Access Compliance Report

Public Rights-of-Way

(Pedestrian Signals)

Intersection ID: N/A	Main Street:	Cross Street: N/A	Location: N/A
ADA ID: 104750E7AE05	Signal Type: Two Push Buttons-APS	Overall Compliance: No	Severity Score: BTN 1:N/A BTN 2: N/A No BTN: N/A
Codes/Mitigation Info/Possible Solution		Field Measurements/Component Compliance

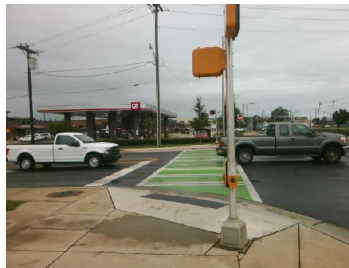
PROW/ADA: TMUTCD 4e.08, R404.2, R406.2,

Yes	B 1 Clear Xing Direction?	ClearlyMarked	Yes	B 2 Clear Xing Direction?	ClearlyMarked
	B 1 Crossing Direction	To E		B 2 Crossing Direction	To NE
Yes	B 1 DistanceTo XWalk (in)	0.0	Yes	B 2 DistanceTo XWalk (in)	0.0
No	B 1 DistanceTo Curb (in)	77.0	No	B 2 DistanceTo Curb (in)	84.0
Yes	B 1 Diameter (in)	2.0	Yes	B 2 Diameter (in)	2.0

Possible Solutions: Replace Signal Push Button With APS Button on New Post. Remove & Relocate Sign.
